Access Compliance Report Public Rights-of-Way (Curb Ramps)

Main Street: CASTLEGATE_LN Cross Street: GLENMERE_DR Location: N

ADA ID: RPRK211008133308 Ramp Type: Type 1 - Perpendicular Diagonal Initial Pass/Fail: Fail Overall Compliance: No Severity Score: 16

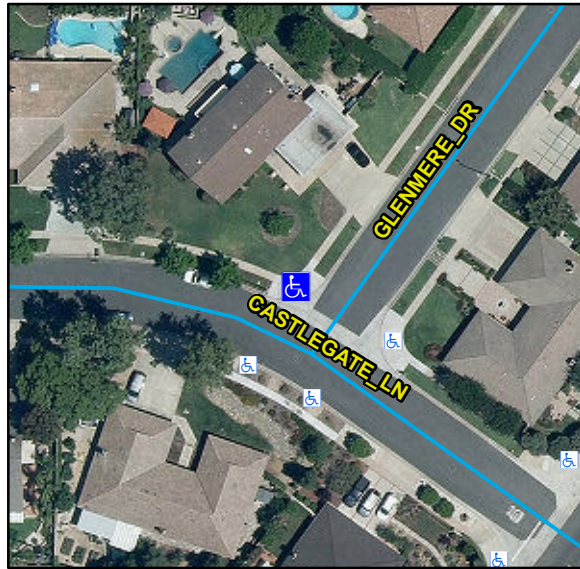
Surveyor Notes:

N/A

Possible Solutions:

Remove & Replace Curb Ramp With Two New Directional Ramps or Equivalent.
